City of Albuquerque

RE: DRAINAGE PLAN FOR NEW DEALERSHIP - PART OF LOT 7, MITSUBISHI
(B-13/D3C) ENGINEER'S STAMP DATED MARCH 28, 1990

NEW DEALERSHIP - LOT 7 MITSUBISHI GRADING AND DRAINAGE PLAN

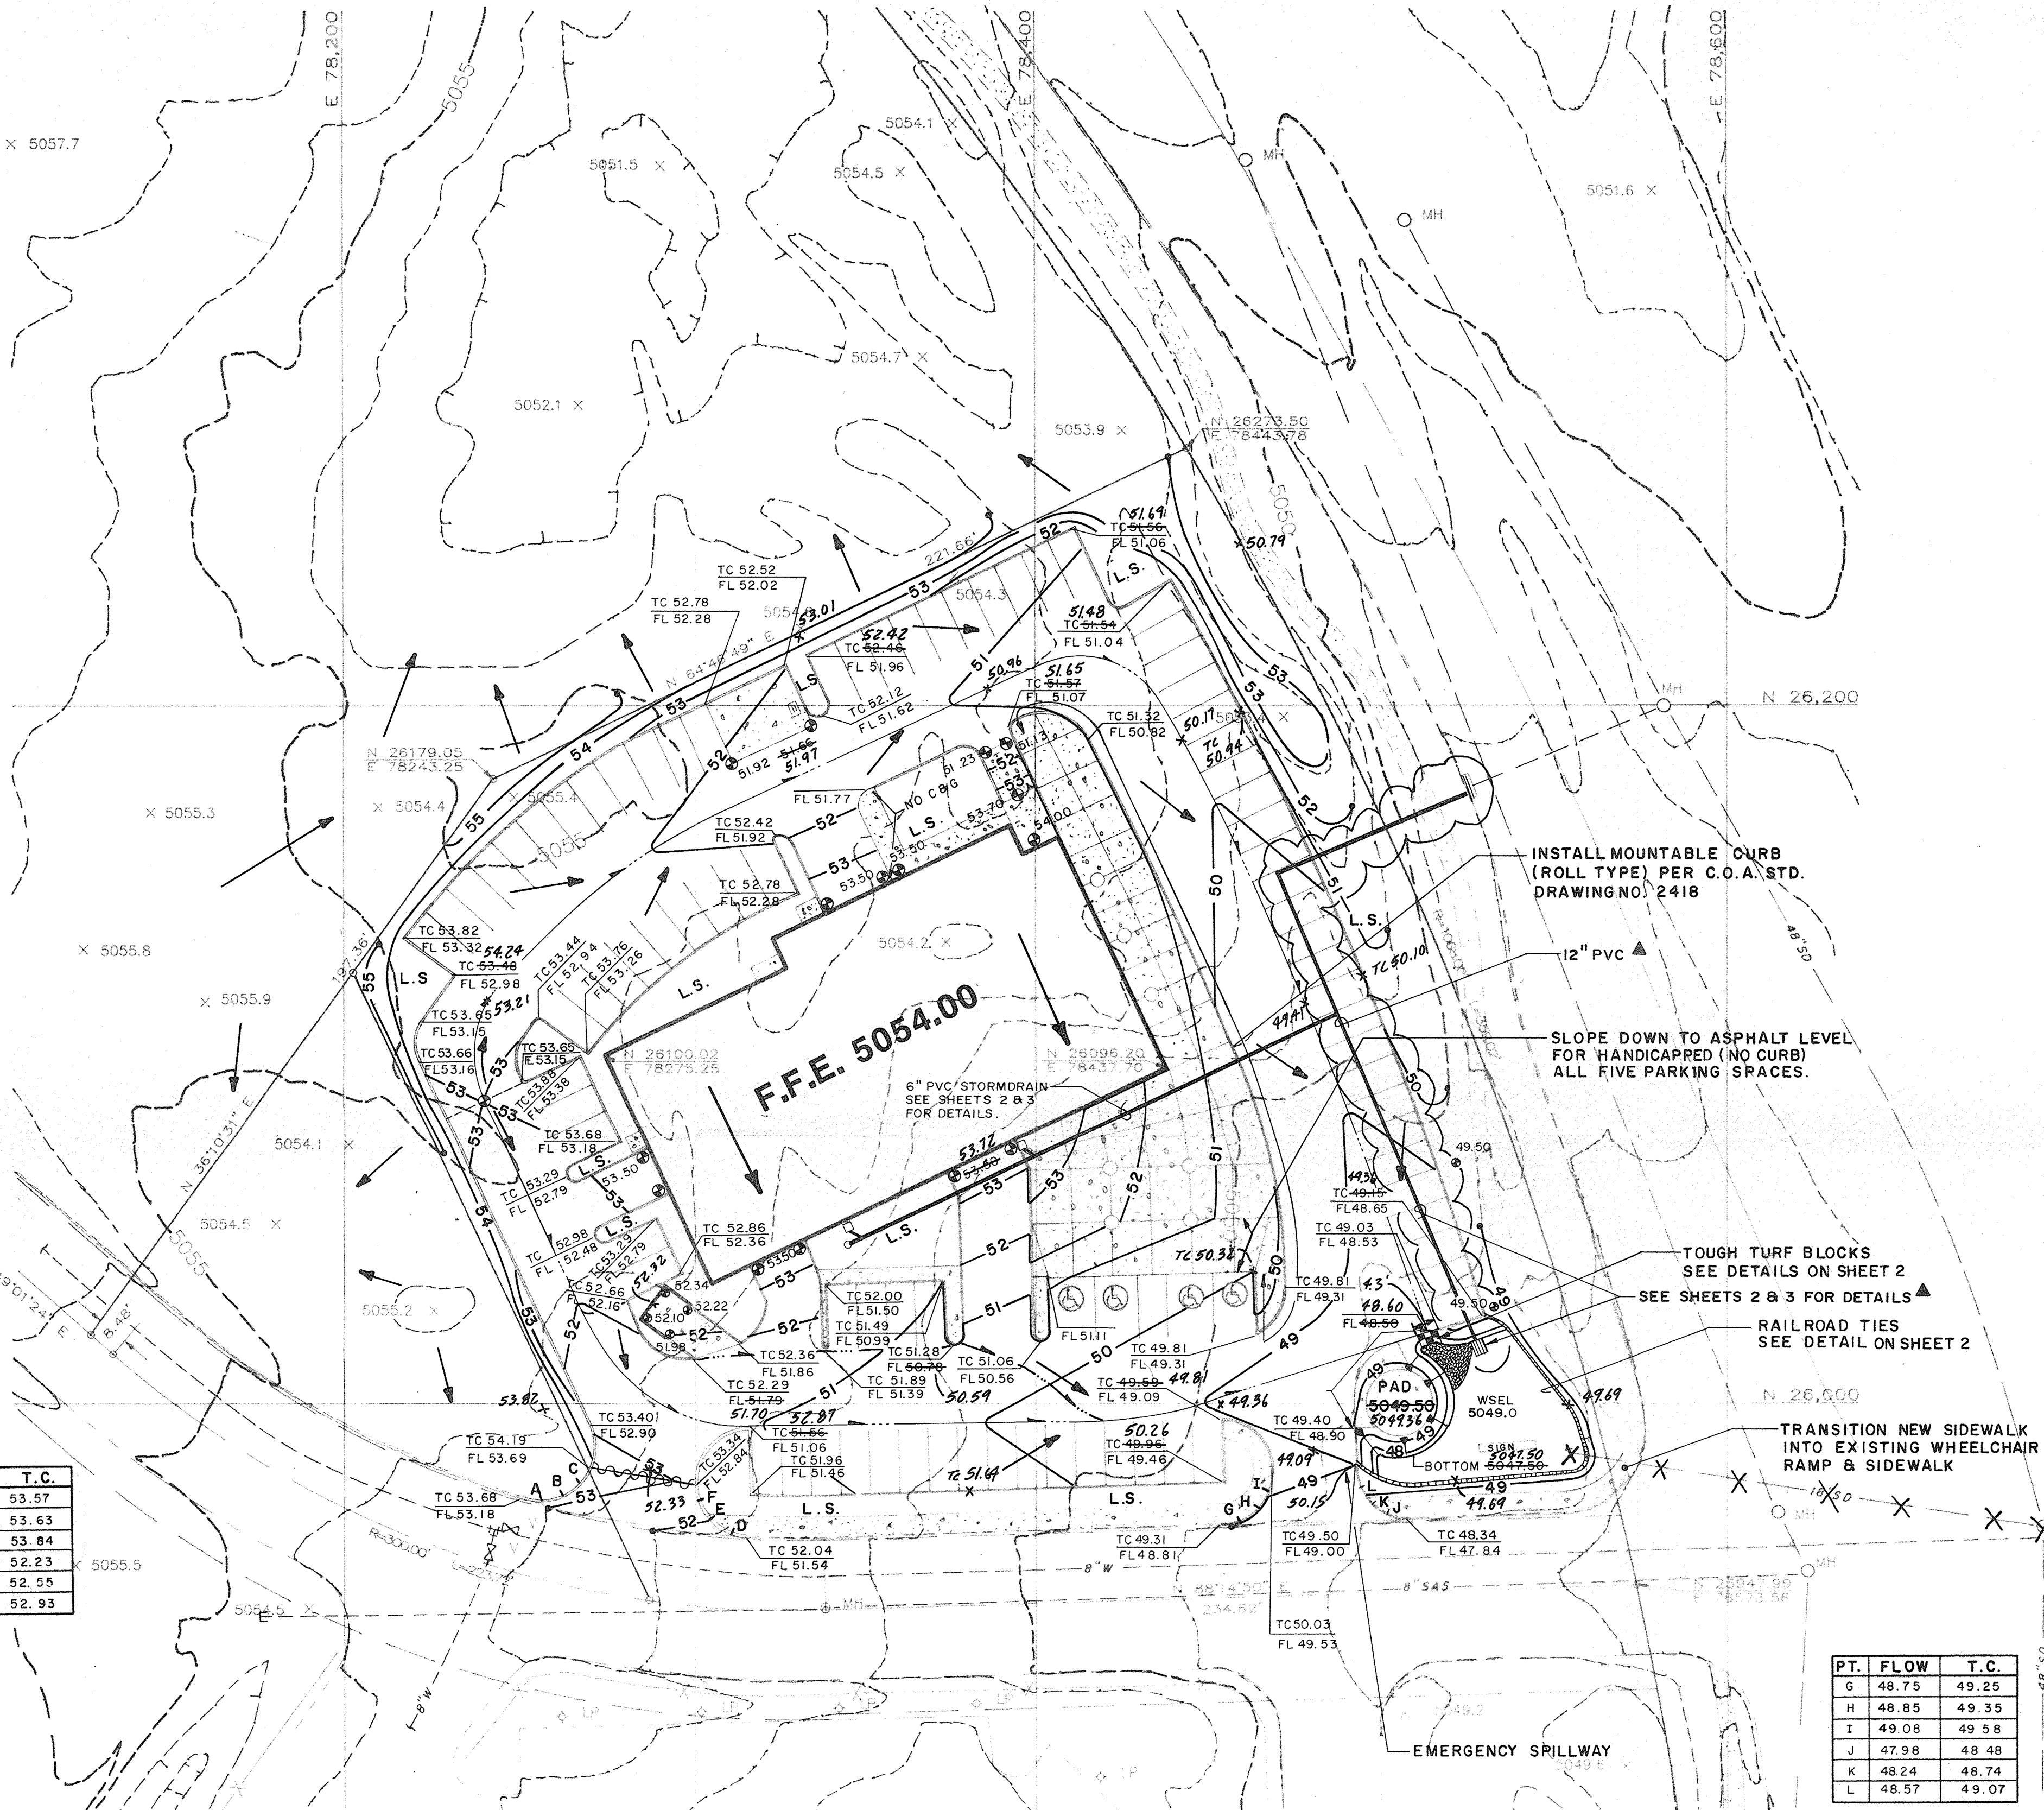
Based on the information provided on your submittal of March 29, 1990, the referenced plan is approved for Building Permit.

Please be advised that a separate permit is required for construction within City right-of-way. A copy of this approval letter will be required when the contractor applies for his excavation permit.

Please attach a copy of this plan to the construction sets prior to sign-off by Hydrology.
